# Access Compliance Report

## Public Rights-of-Way

### (Curb Ramps)

Intersection ID: 17369	Main Street: DELANE_AV	Cross Street: N_SHARON_AMITY_RD	Location: SW
ADA ID: 2A7C5581B7E2	Ramp Type: PerpDiag	Initial Pass/Fail: Fail	Overall Compliance: No
			Severity Score: 21.25

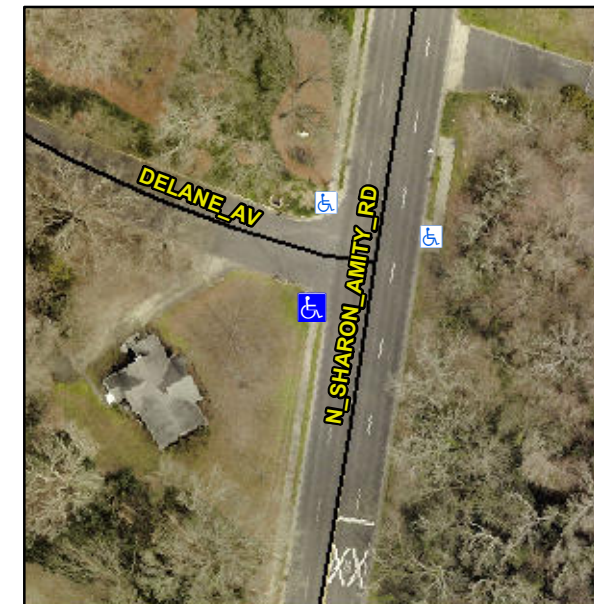
**Not Found, R304.5.1, R304.2.2**

Compliance	Description	Data	Compliance	Description	Data
N/A	Ramp Length (in)	39.0	No	Ramp Slope (%)	8.7
No	Ramp Width (in)	43.0	Yes	Ramp XSlope (%)	1.7
N/A	Flare Type LT	N/A	N/A	Flare Type RT	N/A
N/A	Flare Slope LT (%)	N/A	N/A	Flare Slope RT (%)	N/A
N/A	Flare Traversable LT?	N/A	N/A	Flare Traversable RT?	N/A
N/A	Landing Length (in)	N/A	N/A	DWS Provided?	N/A
N/A	Landing Width (in)	N/A	N/A	DWS Contrast?	N/A
N/A	Landing Slope (%)	N/A	N/A	DWS Length (in)	N/A
N/A	Landing X Slope (%)	N/A	N/A	DWS Full Width?	N/A
N/A	Landing Curb? (Y/N)	N/A	N/A	DWS Offset (in)	N/A
N/A	Shared Landing?	N/A			
N/A	Gutter Ponding?	N/A	N/A	Gutter Slope (%)	N/A
N/A	Gutter Lip Ht (in)	N/A	N/A	Gutter X Slope (%)	N/A
N/A	Painted X Walk1?	No	N/A	Painted X Walk2?	No
	X Walk 1 Direction	To SE		X Walk 2 Direction	To NE
N/A	X Walk 1 Width (in)	N/A	N/A	X Walk 2 Width (in)	N/A
	X Walk 1 Slope (%)	6.4		X Walk 2 Slope (%)	0.5
	X Walk 1 X Slope (%)	0.9		X Walk 2 X Slope (%)	4.7

**Remove & Replace Curb Ramp With Two New Directional Ramps or Equivalent.**
